RESPONSE TO REQUEST FOR ADDITIONAL INFORMATION

US-APWR Design Certification

RAI NO.: NO. 1060-7285 REVISION 4
SRP SECTION: 03.07.02 – Seismic System Analysis
APPLICATION SECTION: 3.7.2
DATE OF RAI ISSUE: 11/15/2013

QUESTION NO. 03.07.02-231:

Figure 2 ATF at Center, Basemat Bottom (el. -39.667 ft), NS Direction, FVM,270-200 Soil

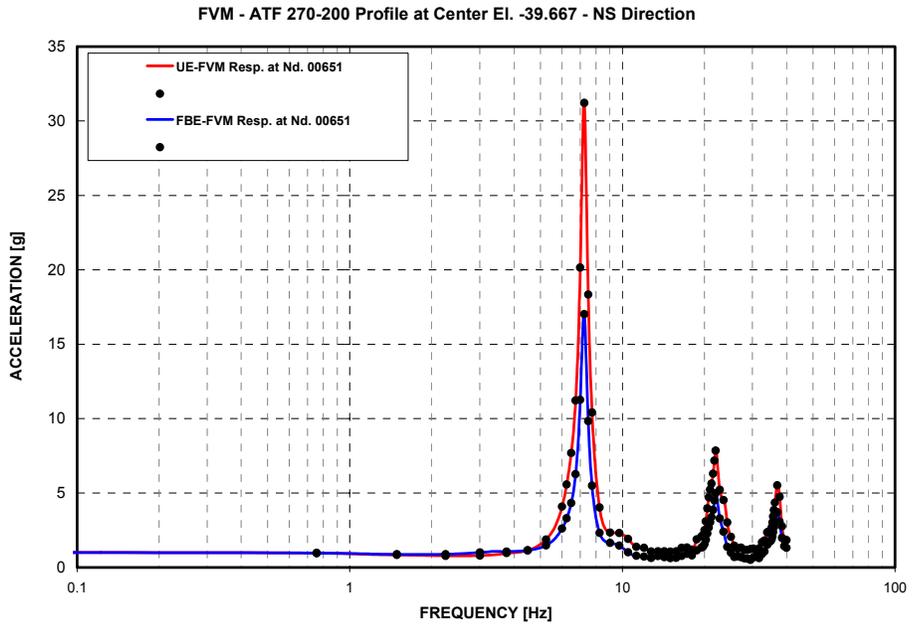
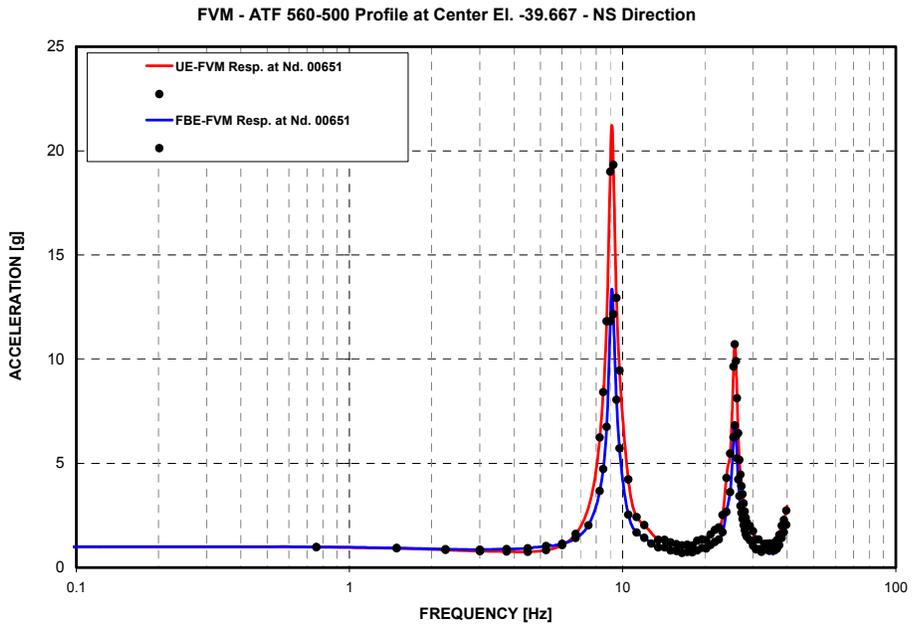
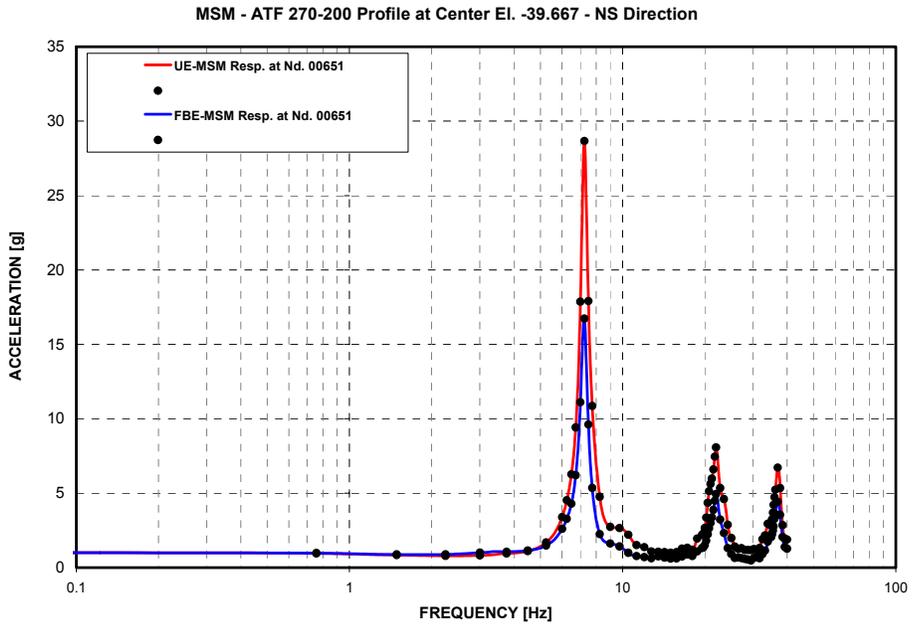
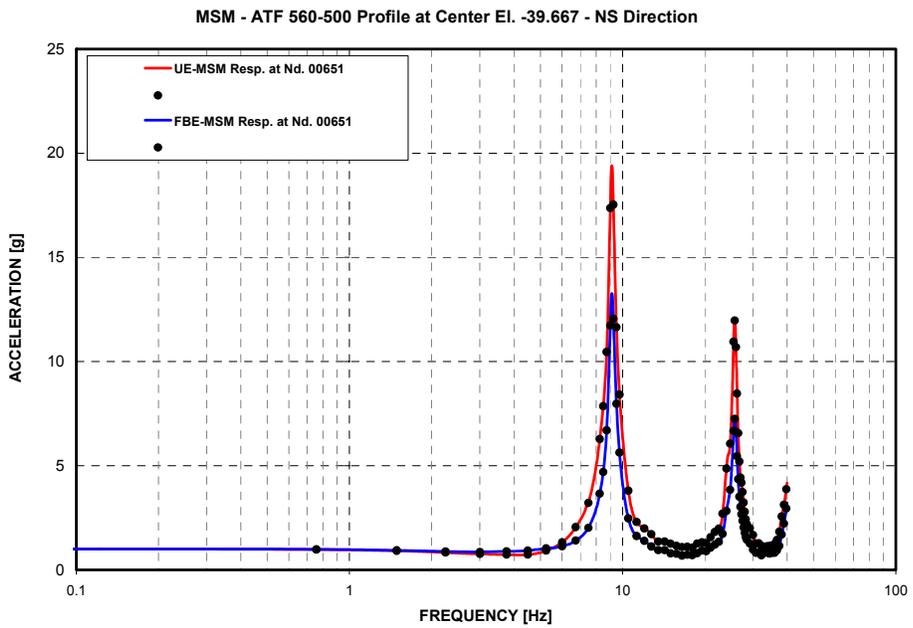
- (4) The bonding of the embedded structure to the side soil differs in the studies described in the RAI response and in the design basis analysis described in the technical report MUAP-10006, Revision 3. The comparison study denoted "study 1" in the RAI response considers both unbonded and fully bonded cases, but the comparison study denoted "study 2" considers only the unbonded case. In MUAP-10006, Revision 3, on the other hand, only fully

bonded conditions are considered. To assess the impact of the unbonded vs. bonded assumption, provide additional figures that compare the results for the unbonded vs. bonded cases that correspond to Figures 1 through 4 in the RAI response (study 1).

(4) Acceleration Transfer function (ATF) comparison plots obtained from the Study 1 for unbonded vs. fully bonded are provided as shown in Figure 2 through Figure 5. The corresponding 5% damped Acceleration Response Spectra (ARS) comparison plots are provided in Figure 6 through Figure 9. In both the ATF and the ARS plots, the unbonded

case (UE) is represented by a red line and the fully bonded case (FBE) is represented by a blue line. Please note that the comparisons are made for the response from kinematic interaction only. See response to Question 03.07.02-233 Part 2 for the embedment condition effects on the seismic response of the R/B complex including both effects of inertia and kinematic interactions.
